UNITED STATES PATENT AND TRADEMARK OFFICE

Office Action Summary

10/726,601

CHANG, CHIH-MIN

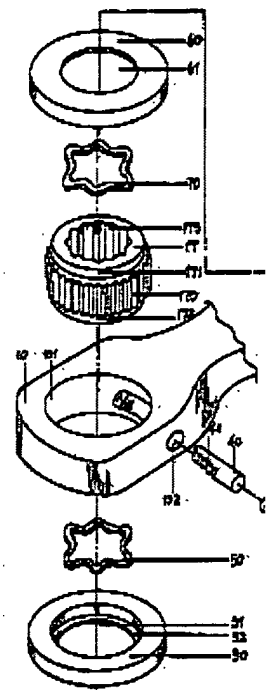
2. Claims 1-3, 5 and 6 are rejected under 35 U.S.C. 102(b) as being anticipated by Lee (4,991,468).

Lee discloses all of the limitations of claim 1, i.e., a ratchet wrench including a handle having a hole at an end thereof; a ratchet wheel (17) having a polygonal hole at a center thereof, a first teeth portion at an annular outer surface thereof, and two engagement portions (171) (172) disposed respectively at opposite ends thereof; said ratchet wheel being rotatably mounted in the hole of the handle with the engagement portions protruded out of the hole of the handle; a pawl (40) mounted in the hole of the handle and having a second teeth portion detachably meshed with the first teeth portion of the ratchet wheel, and two annular members (30) (60) firmly fastened to the engagement portions of the ratchet wheel respectively, said annular member each having an outer diameter greater than a diameter of the hole of the handle.

Regarding claims 2 and 3, Lee meets the limitations, e.g., engagement portions coaxially disposed.

Regarding claims 5 and 6, Lee meets the limitations, e.g., embossments (70) provided at a wall of the hole of the annular members and engagement portion of the ratchet wheel.

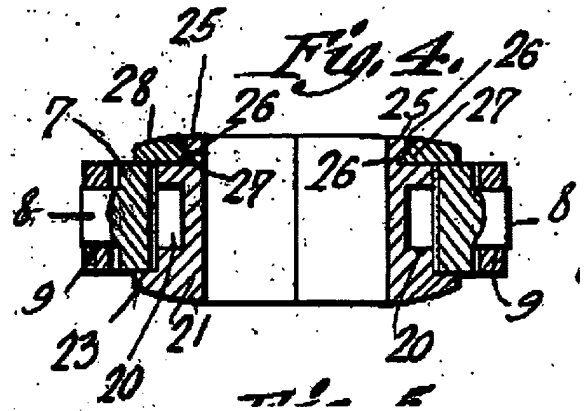
3. Claims 9-11 and 13-16 are rejected under 35 U.S.C. 102(b) as being anticipated by Cross (1,331,956).

Cross discloses all of the limitations of claim 9, i.e., a ratchet wrench including a handle having a hole (an opening through something as defined by Webster) at an end thereof; a ratchet wheel (20) having a polygonal hole at a center thereof, a first teeth portion at an annular outer surface thereof, an engagement portion (24,25) at one end, an annular flange (23) having a diameter greater than the hole at the other end; said ratchet wheel being rotatably mounted in the hole of the handle with the engagement portion and the annular flange protruded out of the hole of the handle; a pawl (19) mounted in the hole of the handle and having a second teeth portion detachably meshed with the first teeth portion of the ratchet wheel, and an annular member (28) firmly fastened to the engagement portion of the ratchet wheel respectively, said annular member having an outer diameter greater than a diameter of the hole of the handle.

Regarding claims 10 and 11, Cross meets the limitations, e.g., engagement portions coaxially disposed.

Regarding claims 13 and 14, Cross meets the limitations as recited, i.e., "embossments" (8) and (9).

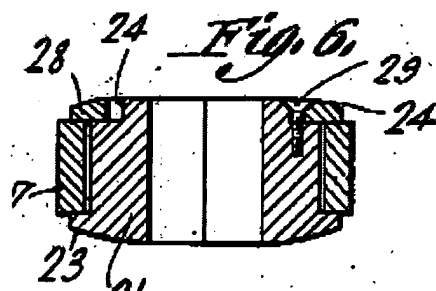
Regarding claims 15 and 16, Cross meets the limitations as recited, i.e., screw thread connection (29) and sloped surfaces (26) and (27).
